Access Compliance Report

Public Rights-of-Way

(Pedestrian Signals)

Intersection ID: N/A	Main Street:	Cross Street: N/A	Location: N/A
ADA ID: 7F1CD1E5A093	Signal Type: One Push Button-APS	Overall Compliance: No	Severity Score: BTN 1: N/A BTN 2: N/A No BTN: N/A
Codes/Mitigation Info/Possible Solution		Field Measurements/Component Compliance

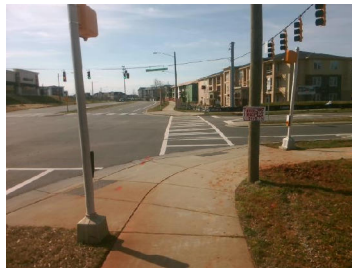
Surveyor Notes: N/A

PROW/ADA: TMUTCD 4e.08, R404.2, R406.2, R209.1, MUTCD 4e.10

Possible Solutions: Replace Signal Push Button With APS Button on New Post. Remove & Relocate Sign.
